SOUTH DOWNS NATIONAL PARK AUTHORITY

SDNPA Consultation Response

Draft Response

1. The South Downs National Park Authority (SDNPA) notes that Highways England (HE) is consulting on a single option only for the M3 Junction 9 scheme. The proposal (option 14) is to provide free flowing road links between the M3 and the A34 both northbound and southbound. The new road connections will pass each other and the existing M3 via a combination of flyovers and underpasses. New embankments, cuttings and retaining walls will be required to achieve this.

Noise Regulation Capacity

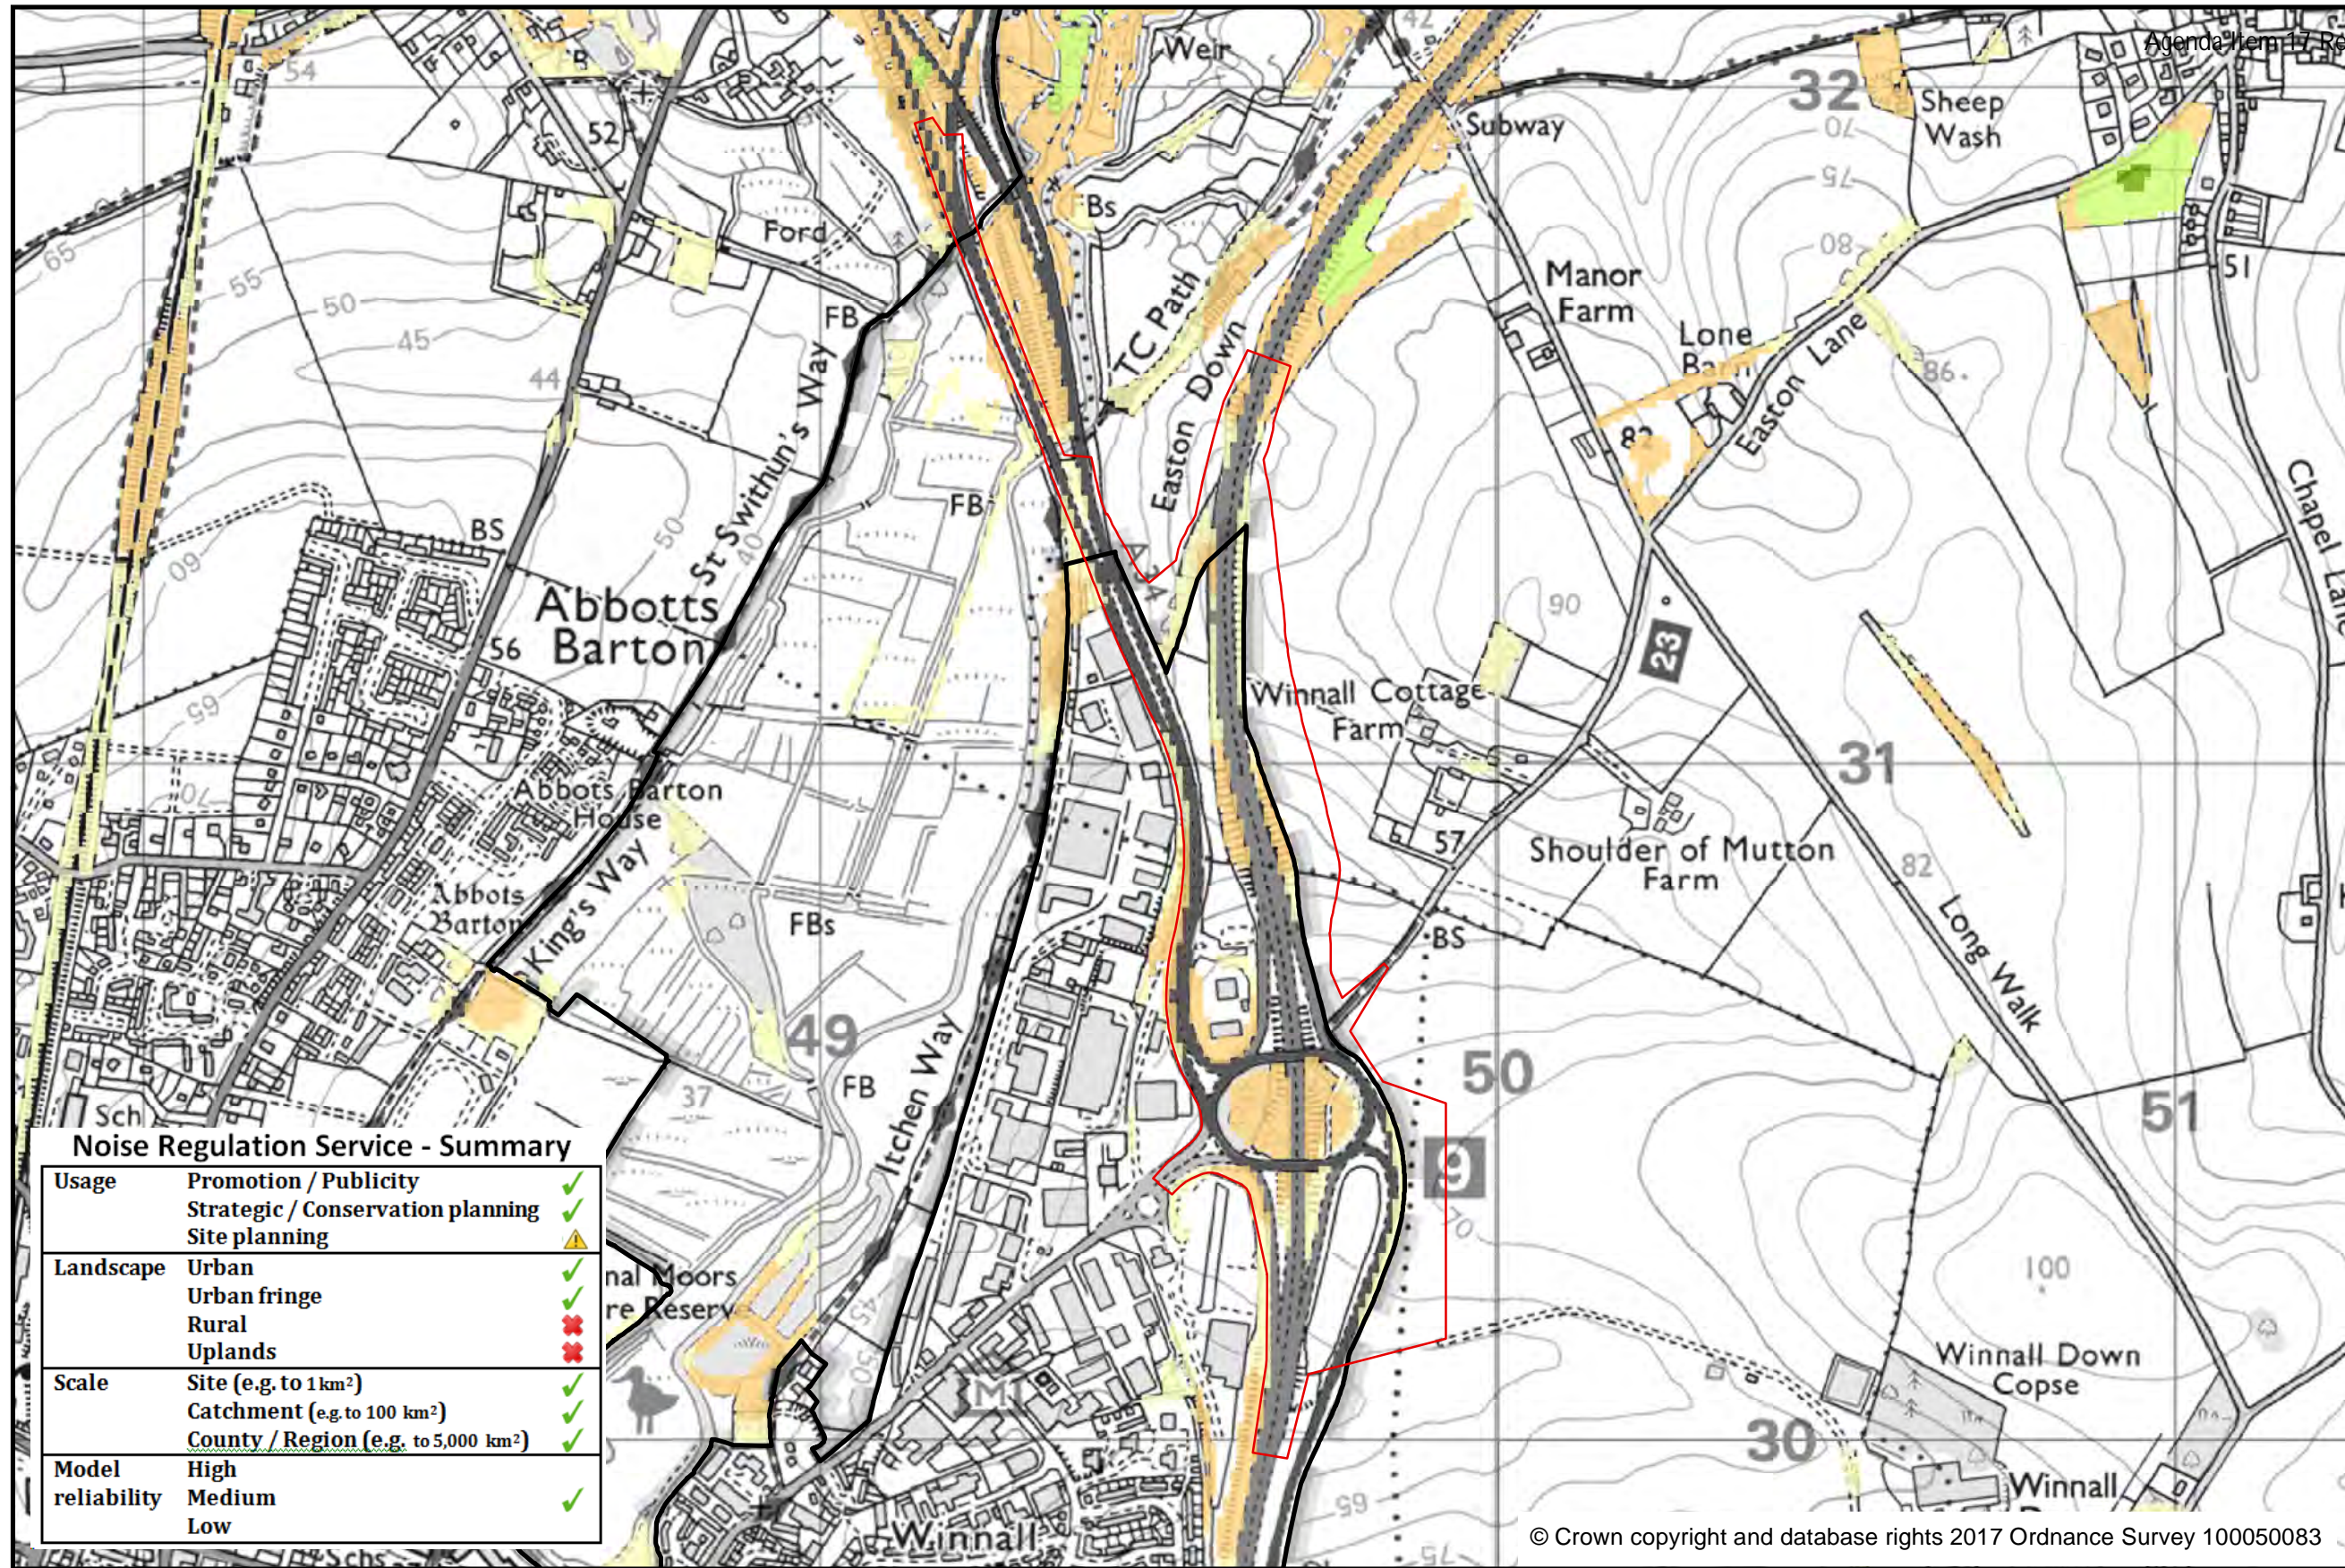
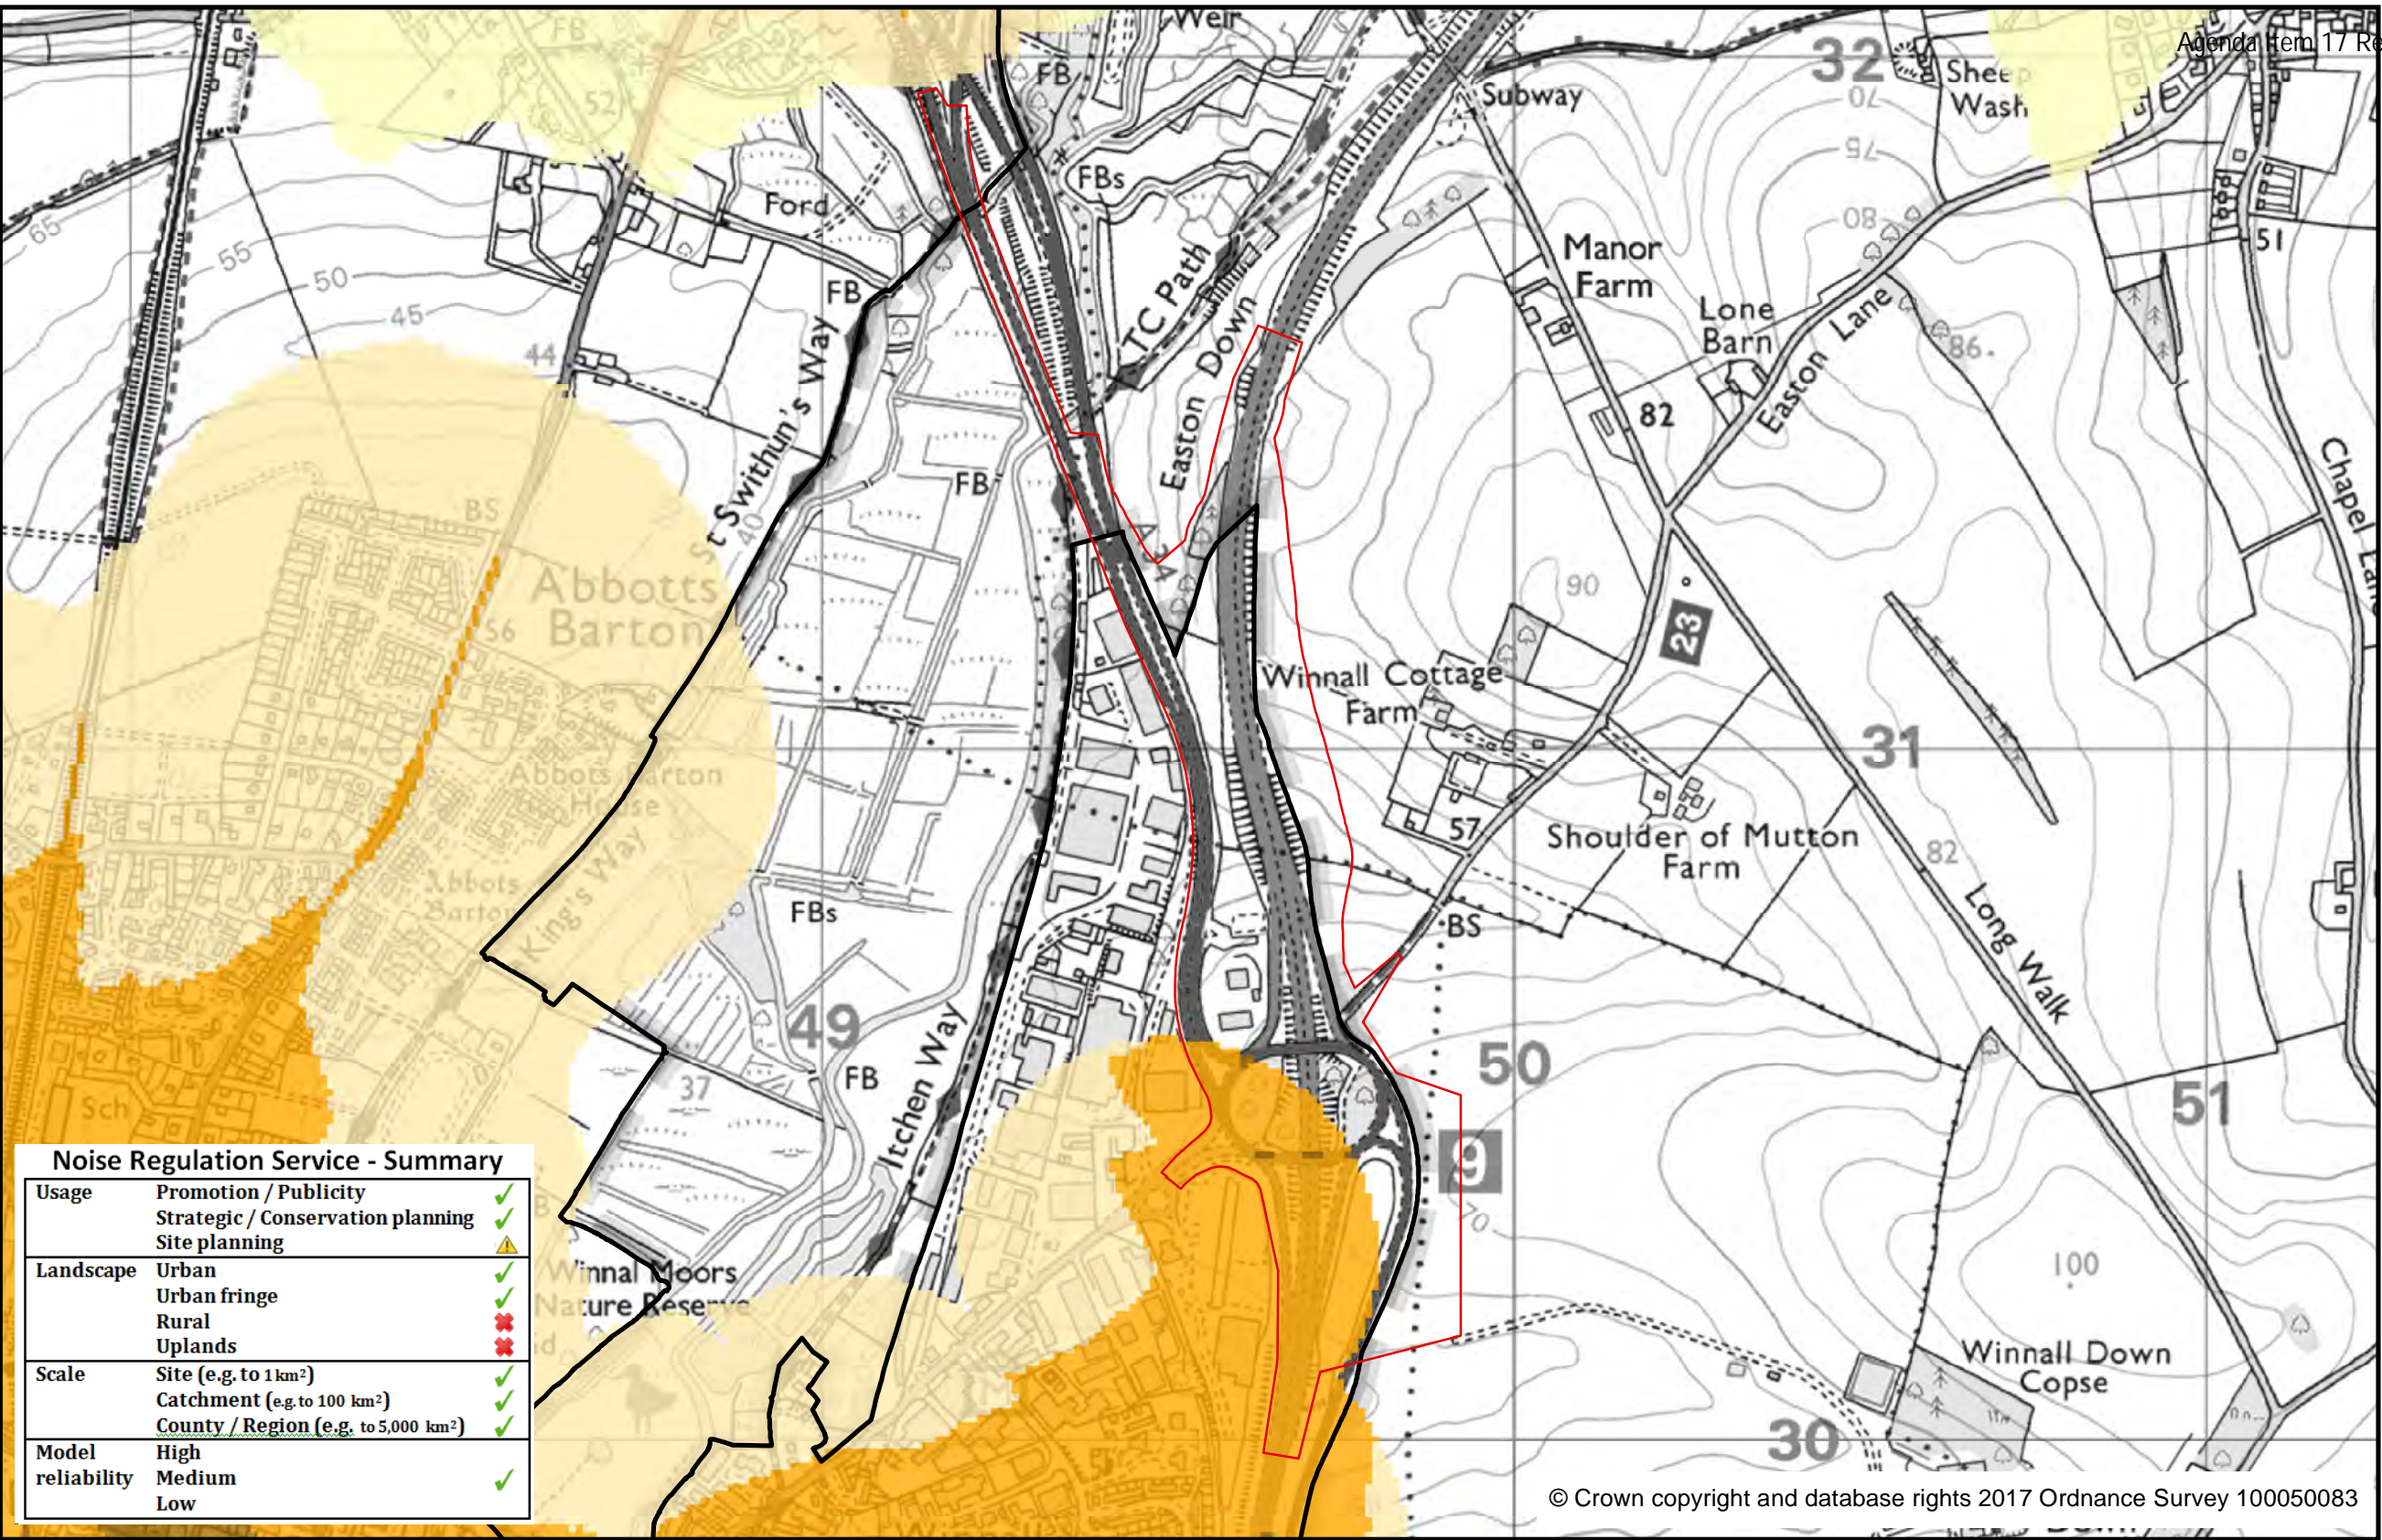
- 7.12. Noise regulation This is an ecosystem function of the landscape and its features. It is considered that the existing bands of trees along the line of the A34 to Newbury and its junction with the A33 provide some capacity to screen and regulate noise from the road. This is helped to a degree by the existing topography and current un-elevated nature of the road. The M3 is more elevated, but again is screened by bands of trees and mature scrub vegetation along the fringes of Easton Down. The need for noise regulation in this location is fairly high particularly for the urban fringe areas of Winchester at Abbots Barton and Winnal. These are highlighted as areas that need to be improved in terms of noise regulation, through screening or planting. (See maps figure x)

Capacity – the existing bands of trees along the line of the A34 to Newbury and its junction with the A33 provide some capacity to screen and regulate noise from the road. This is helped to a degree by the existing topography and current un-elevated nature of the road. The M3 is more elevated, but again is screened by bands of trees and mature scrub vegetation along the fringes of Easton Down.

Demand – The need for noise regulation in this location is fairly high particularly for the urban fringe areas of Winchester at Abbots Barton and Winnal. These are highlighted as areas that need to be improved in terms of noise regulation, through screening or planting.

Impact of the proposals on the current situation – The proposed scheme would firstly cause the loss of many of the mature trees and areas of scrub that currently provide this service benefit. This would increase the current issue around road noise. In addition by raising some sections of the A34/A33 onto an embankment across the Itchen Valley this will be further exacerbated. The M3 corridor at this section will also become more prominent both visually and in terms of noise impact. There is a strong case to either retain, or replant, tree and vegetation that would be lost within the red-line of the scheme.
